Contract Number 8766	Contract Title SR 14 6th St. to Bingen Chip Seal	Federal Aid Number NHPP-0014(079)
Change Order Number 14	Change Description Grind and Inlay	Date Sep 9, 2016
Region Southwest Region	Project Engineer Susan Fell	Phone Number 360-759-1310
Prime Contractor / Design-Builder Granite Construction Co.

Evolution & Description Of Change

CONTRACT NO: 008766 FEDERAL AID NO: NHPP-0014 (079)
 CONTRACT TITLE: SR 14, 6TH ST TO BINGEN - CHIP SEAL
 CHANGE ORDER NO: 14 GRIND & INLAY

ROADWAY SECTION I
 -SR 14 MP 44.07 - 44.55 -
 -SR 14 MP 64.86 - 66.84 -
 SR 14 MP 44.07 - 44.60

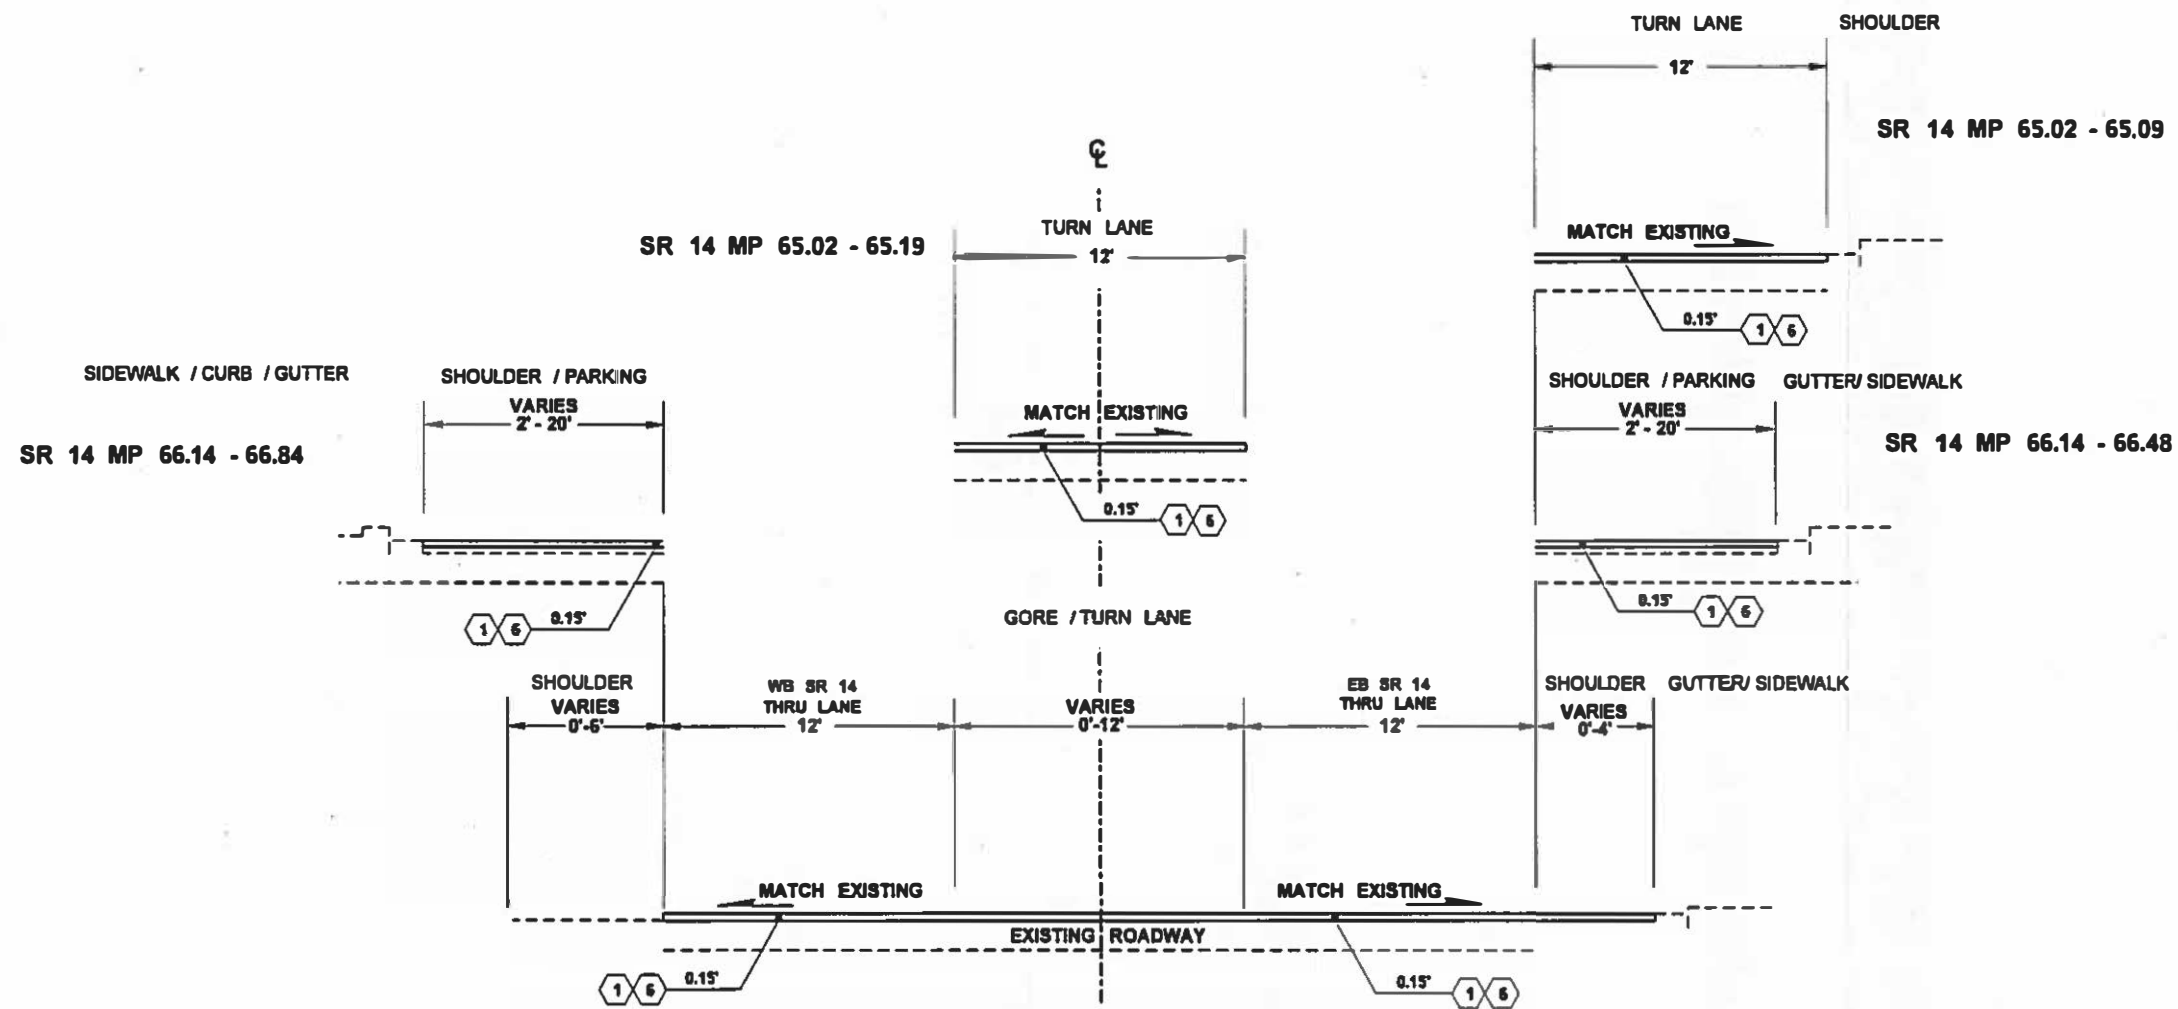
This change order revises one plan sheet and creates one new plan sheet. It also adds the following new items and directs the contractor to perform the following items of work as marked by the engineer and as detailed in the attached plan sheets:

SR 14 milepost 44.07 to 44.60, near Stevenson.

Grind approximately 12,700 square yards at a depth of 0.15ft. "Planing Bituminous Pavement-CO 14".

Pave approximately 1,300 tons "HMA CL 3/8 IN. PG 64-22CO 14".

- 1 PLANNING BITUMINOUS PAVEMENT, HMA CL 1/2 IN. PG 64-22, AND FURN. AND PLACING PRECOATED CRUSHED SCREENINGS SHALL EXTEND 0.5' BEYOND FOG LINE INTO EXISTING SHOULDER WHERE SHOULDERS ARE 2' OR LESS EXTEND LIMITS TO EDGE OF PAVEMENT.
 - 3 CONCRETE CROSSWALKS AT MP 44.15, MP 44.32, MP 44.36, MP 44.46, MP 44.60, AND THE INTERSECTION BETWEEN MP 42.26 AND MP 44.28 ARE EXEMPT AND SHALL BE PROTECTED.
- ALL DEPTHS SHOWN ARE COMPACTED DEPTHS.
